Platt Technical High School

ADDENDUM NO. 4

August 9, 2019

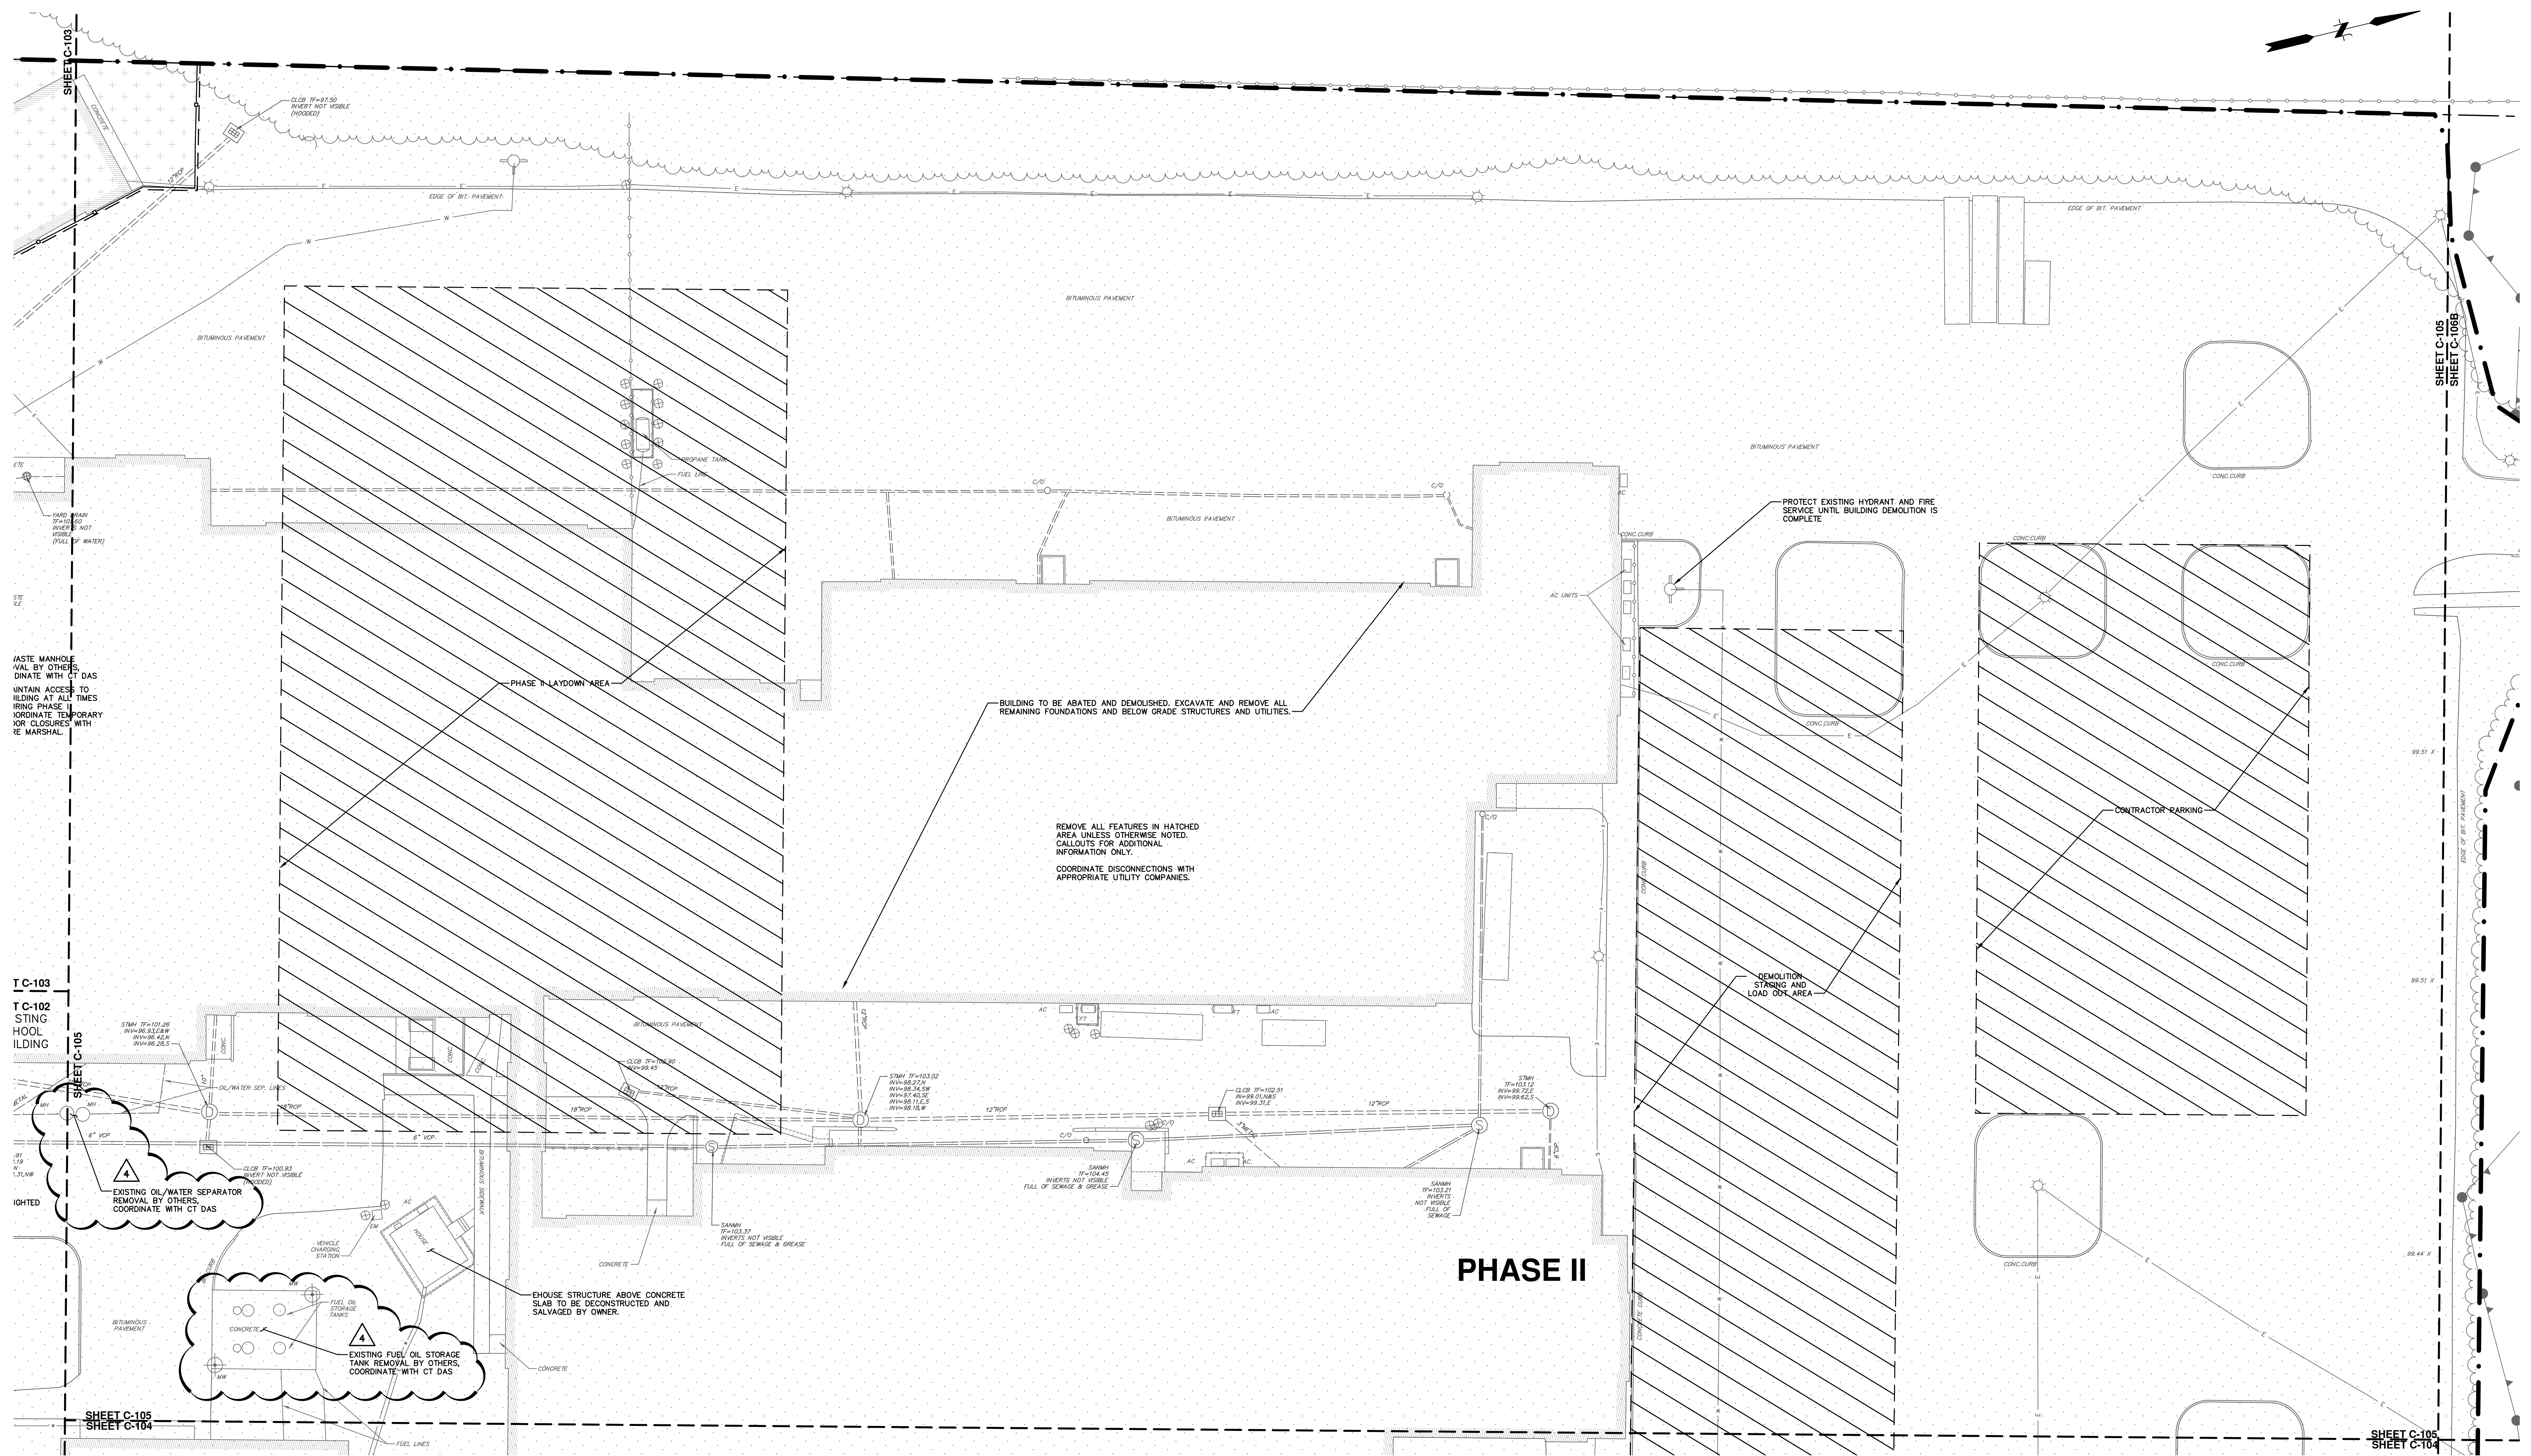
- ADD 4-063** **DRAWING C-103 – PHASE I SITE PREPARATION PLAN**
Revised oil waste manhole removal note.
- ADD 4-064** **DRAWING C-105 – PHASE II SITE PREPARATION PLAN**
Revised oil/water separator and fuel soil storage tank removal notes.
